MEMORANDUM

RE: Completion of Remedial Design
12th Street Landfill, Operable Unit No. 4
Allied Paper, Inc./Portage Creek/Kalamazoo River Superfund Site
Allegan and Kalamazoo Counties, Michigan

2.0 CRA's COMMENTS ON THE PRE-FINAL DESIGN

figure 1
 CONCEPTUAL REVISED GRADING PLAN
 3:1 GRADING ALTERNATIVE
 12th STREET LANDFILL
Otsego Township, Michigan

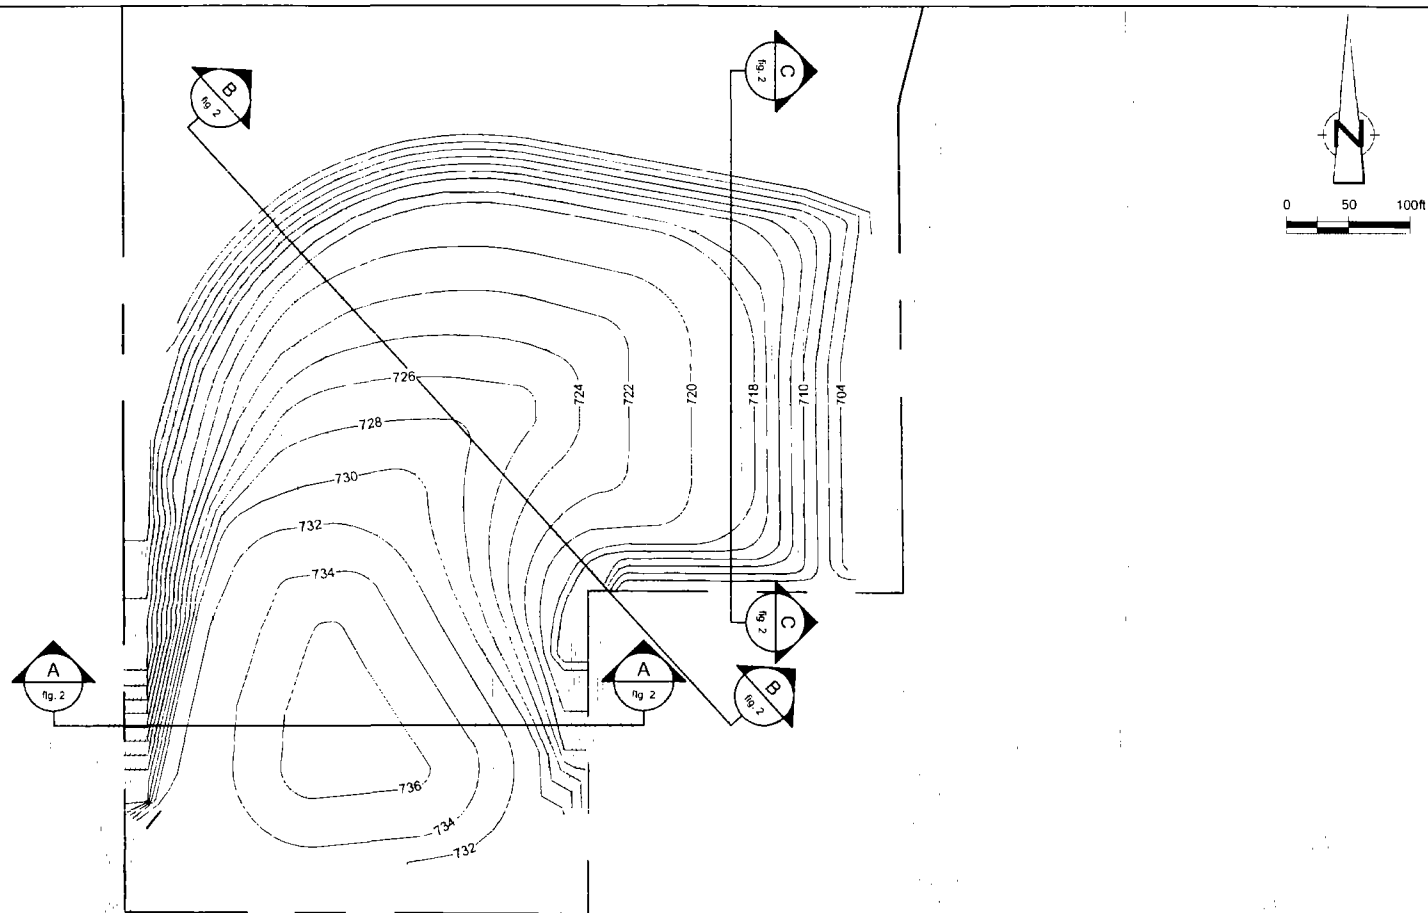
CRA proposes to redesign the slope of the landfill to an typical slope of 3:1, with the exception of the current 5:1 slope on the east side along the Kalamazoo River. The result of the change in slope will have the following affect on the RA:

- Reduce the amount of material to be cut from the slopes to achieve grades to approximately 8,500 cubic yards (from 38,800 cubic yards);
- Reduce the total capacity of the material that could be placed under the cap to 25,000 cubic yards and reduce the height of the landfill to 736 feet above mean sea level (AMSL) from 740 feet AMSL in the current design; and
- The total capacity for off-site fill material under this scenario is approximately 4,000 cubic yards but could be as high as 12,000 cubic yards should capacity be needed.

Figure 1 shows the conceptual final contours of the cap assuming a 3:1 slope and a top slope elevation of 736 feet AMSL. Selected cross-sections of the cap are provided on Figure 2. It should be noted that the contours shown on Figure 1 are preliminary in nature to show the concept of the revised design with a 3:1 slope. The grades and related cut/fill volumes will need to be fine tuned during the design process.
